# CITY OF ALBUQUERQUE

Site: El Vado/Casa Grande

#### Re: Drainage Ordinance (14-5-2-1) Violations for Erosion and Sediment Control

Stabilized construction exit/Track-out pad in poor condition.

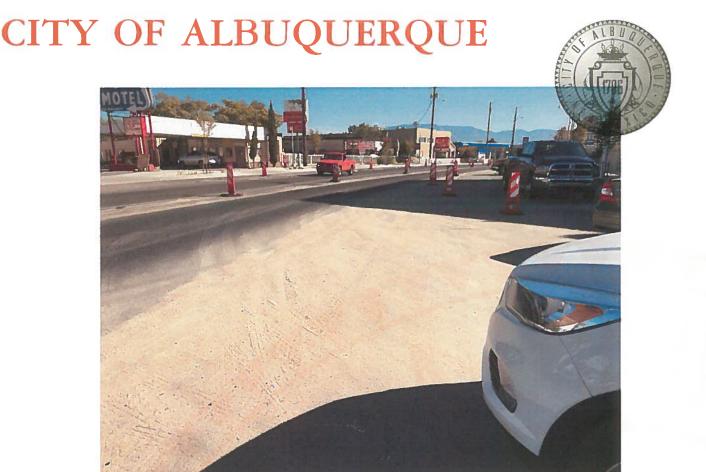
- 1. The stabilized construction exit/track-out pad is in poor condition.
- 2. There was sediment in Central Ave.

Sediment in Central Ave.

- 1. Install a stabilized construction exit/track-out pad per the approved Erosion and Sediment Control plan.
- 2. Remove the sediment from the street and gutter in Central Ave. along the project frontage.
